SOLICITATION AMENDMENT

Title - Sujet SAR Station Building Construction	
Solicitation No. - N° de l'invitation F1700-165108/A	Amendment No. - N° modif. 002
Client Reference No. - N° de référence du client F1700-165108	Date 2016-11-30
GETS Reference No. - N° de référence de SEAG PW-\$PWY-028-7909	
File No. - N° de dossier PWY-6-39207 (028)	CCC No./N° CCC - FMS No./N° VME
Solicitation Closes - L'invitation prend fin at - à 02:00 PM on - le 2016-12-09	
Time Zone Fuseau horaire Pacific Standard Time PST	
F.O.B. - F.A.B. Plant-Usine: <input type="checkbox"/> Destination: <input checked="" type="checkbox"/> Other-Autre: <input type="checkbox"/>	
Address Enquiries to: - Adresser toutes questions à: Lam (PWY), Tian	Buyer Id - Id de l'acheteur pwy028
Telephone No. - N° de téléphone (604) 775-9382 ()	FAX No. - N° de FAX (604) 775-6633
Destination - of Goods, Services, and Construction: Destination - des biens, services et construction: DFO - Prince Rupert SAR Station Building Construction - Prince Rupert, BC

The Solicitation Amendment 002 is raised to issue Addendum #1

***The following changes in the Tender Documents are effective IMMEDIATELY.
This addendum will form part of the Contract D

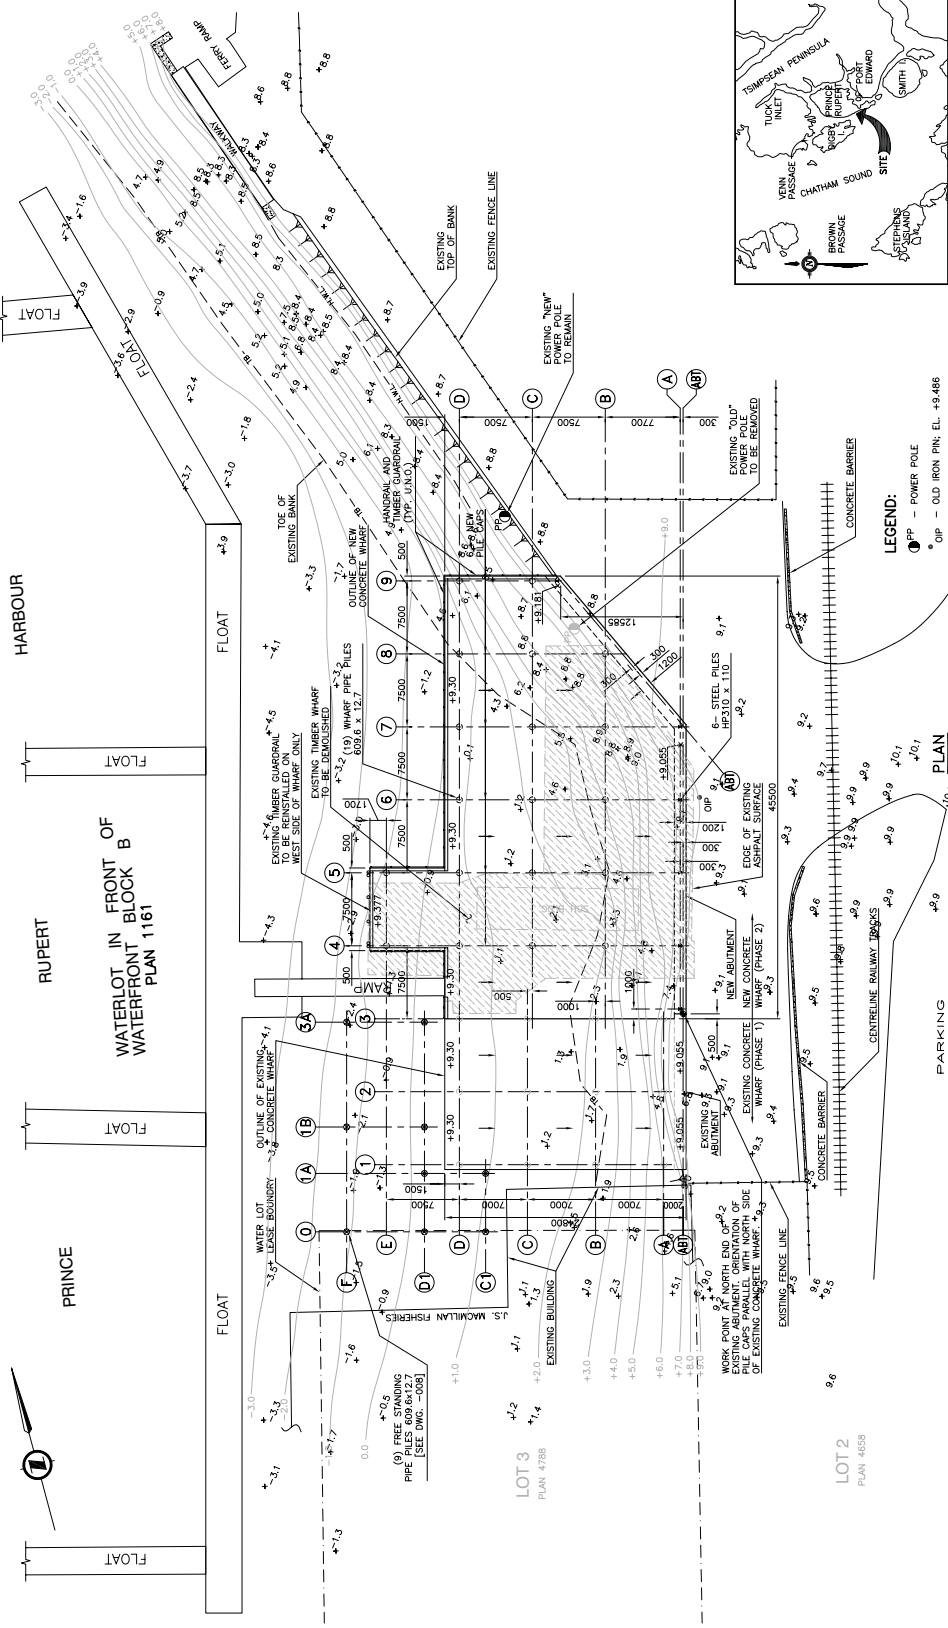
Can you find out what the capacity of the existing concrete wharf is? We want to set a crane up on in to fly in new structural steel

See attached plan of adjacent wharf for general information.

1 TYPICAL ROOF GABLE DETAIL

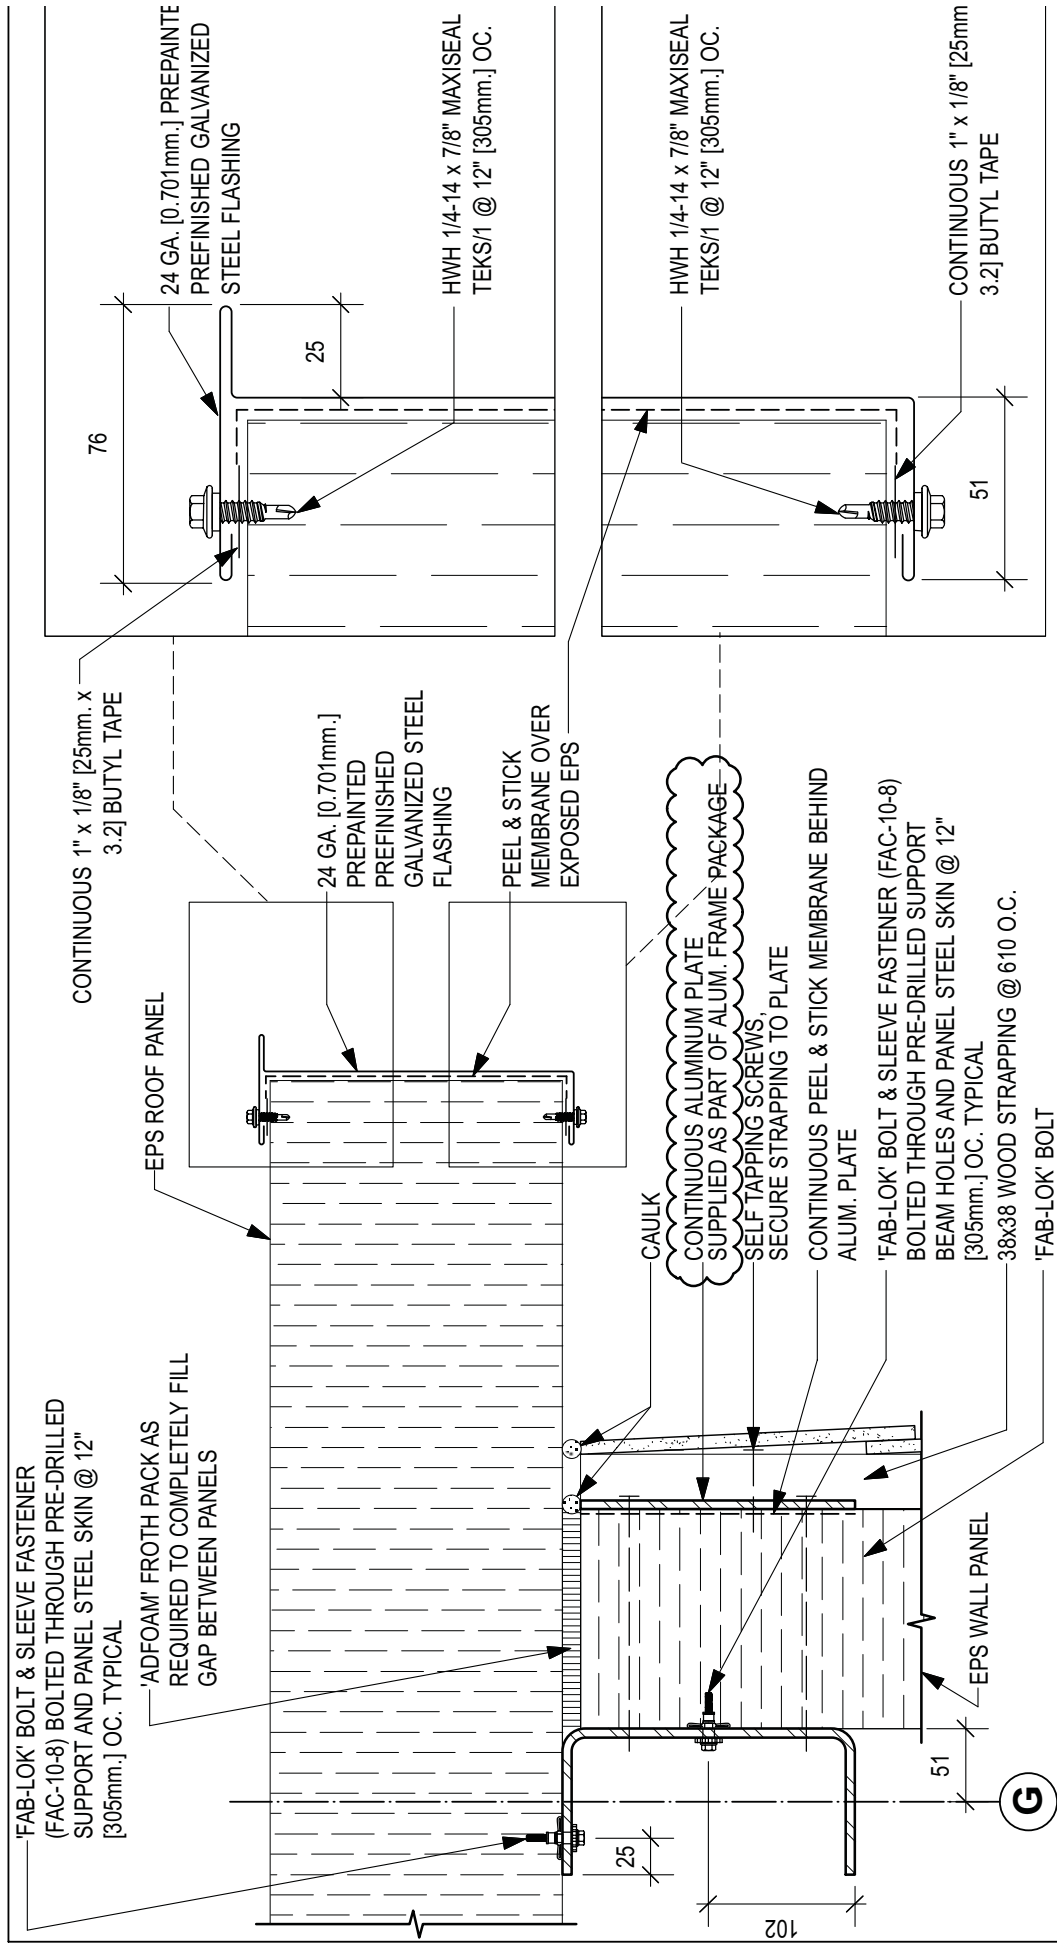
1/A6.02 & 4/A6.03 – see revised attached

See additional items to be provided by owner as part of the Aluminium frame package.
